CITY OF MADISON, WI
MADISON TRUCK EQUIPMENT SHOP BUILDING

SITE PLAN
2405 SOUTH STOUGHTON ROAD

City of Madison Site Plan Verification

Description: Re-submittal of previously approved building expansion to increase the size of building addition.

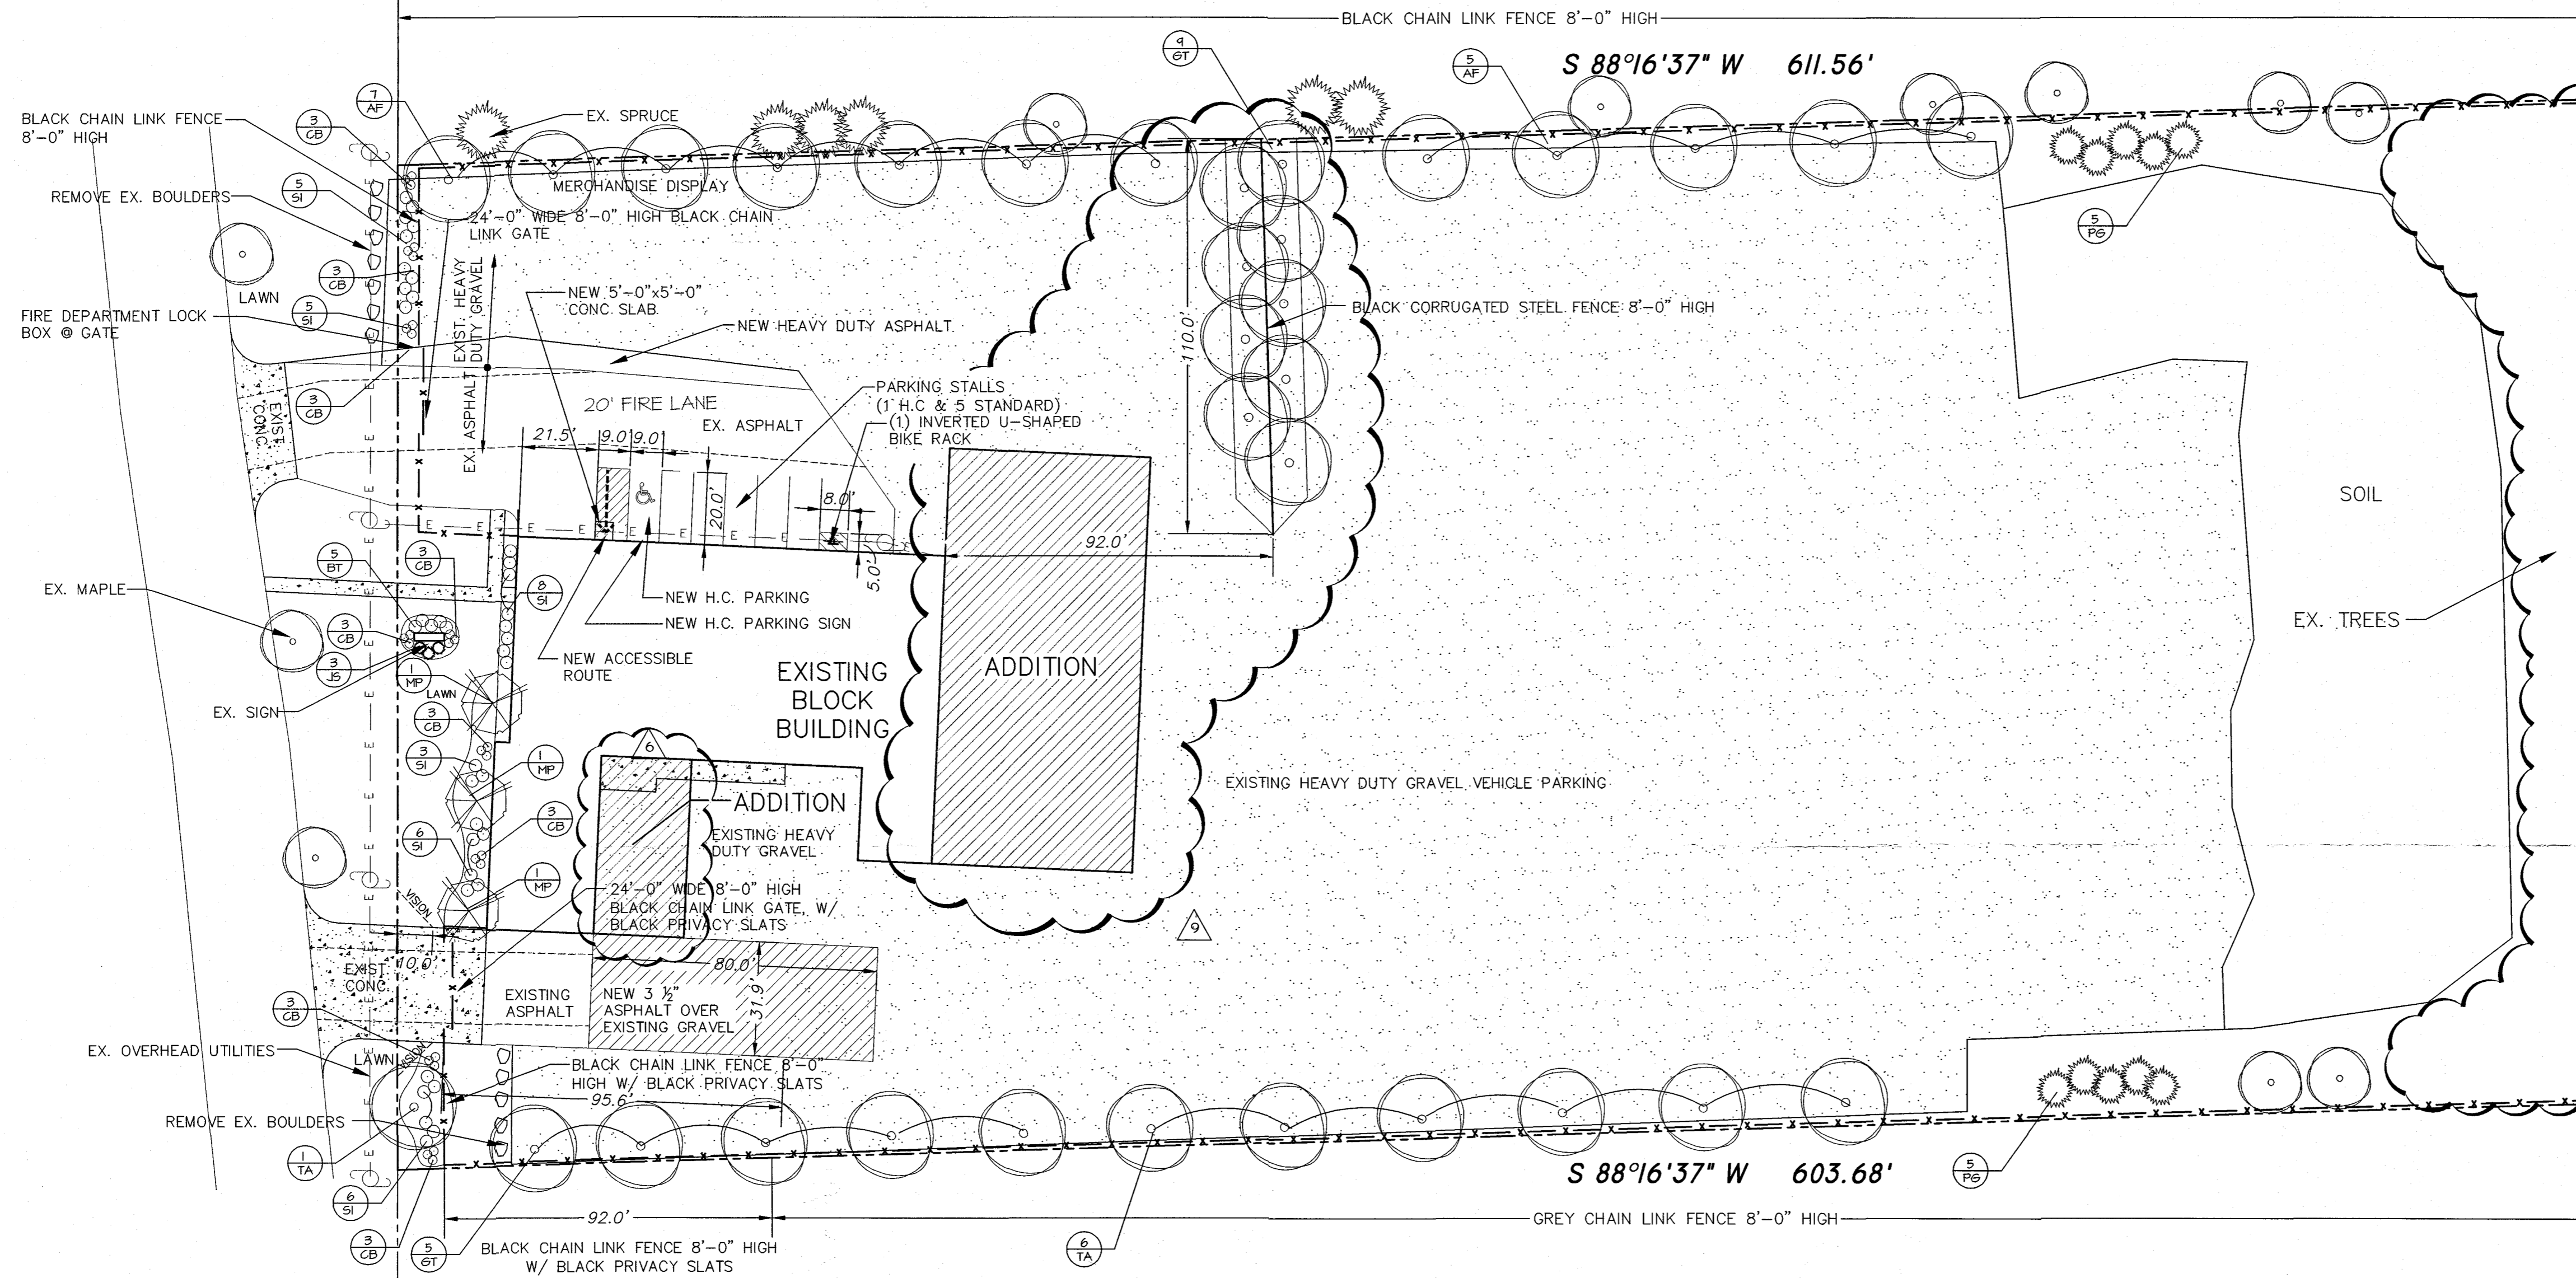
If privacy slats are used on front yard fencing, they must not be used within required vision triangles of driveways (10 ft).

Sites larger than 10,000 sf require a landscape plan stamped by a registered landscape architect.
